Application for Variation of an Environmental Permit

C1. Name of the Current Environmental Permit Holder :
Civil Engineering and Development Department
C2. Application No. of the Current Environmental Permit : EP-470/2013
C3. The Current Environmental Permit was Issued in : month / year
11 | 20 | 13

Project Title
FRESH WATER AND FLUSHING WATER SERVICE RESERVOIRS AND ASSOCIATED WORKS IN FANLING NORTH - DESIGN AND CONSTRUCTION
 粉嶺北食水及沖廁水配水庫及相關工程 - 設計及建造

ENVIRONMENTAL REVIEW REPORT FOR RELOCATION OF FLN FLWSR FROM TONG HANG TO TABLE HILL

Figure 3-1 Originally Proposed FLN FLWSR at Tong Hang Location Plan

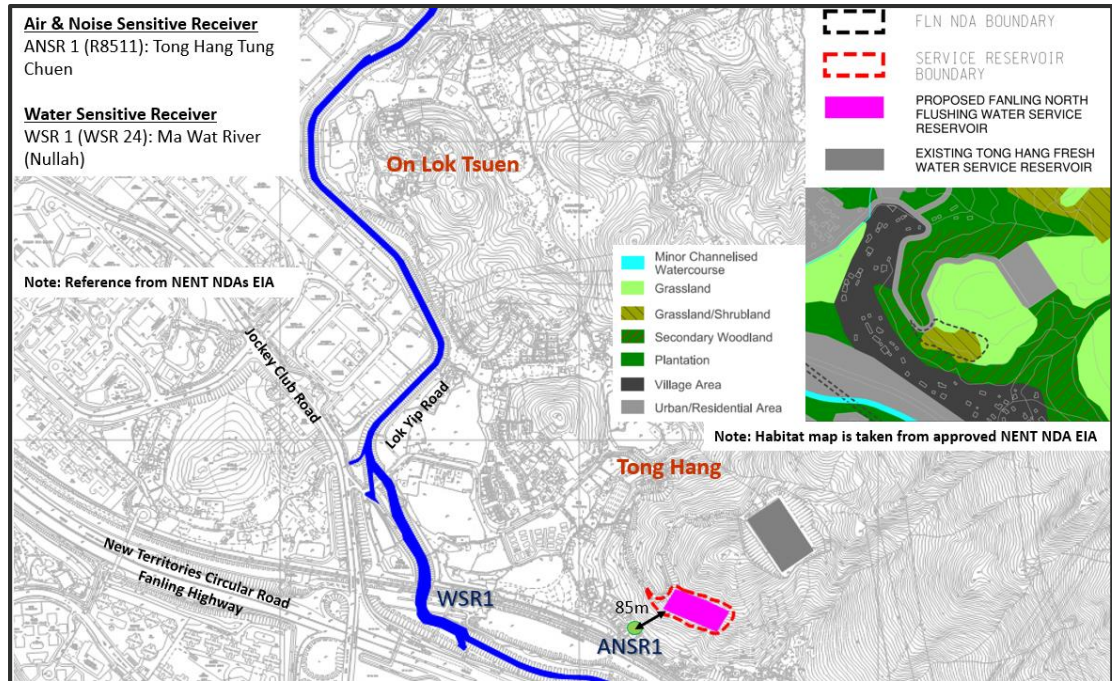
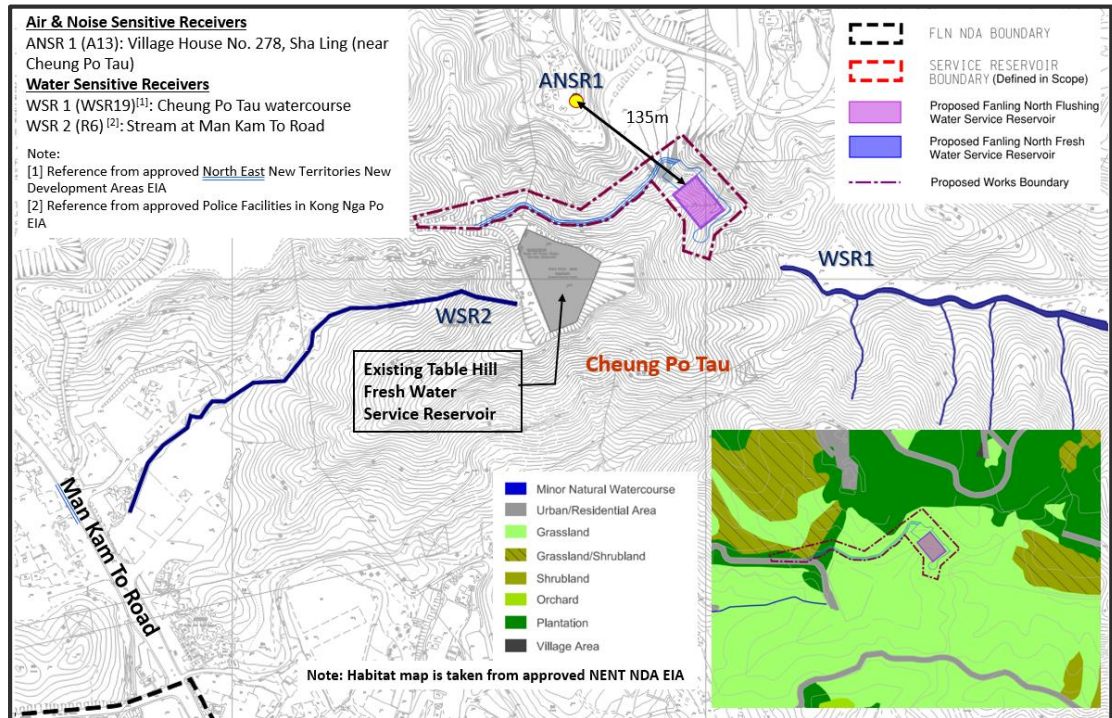
3.1.1 The originally proposed FLN FLWSR is located at Tong Hang where is grassland/shrubland (see **Figure 3-1**), while the newly proposed location for the FLN FLWSR will be adjacent to the existing TBHFWSR where is of similar type of habitat (i.e. grassland) (see **Figure 3-2**).
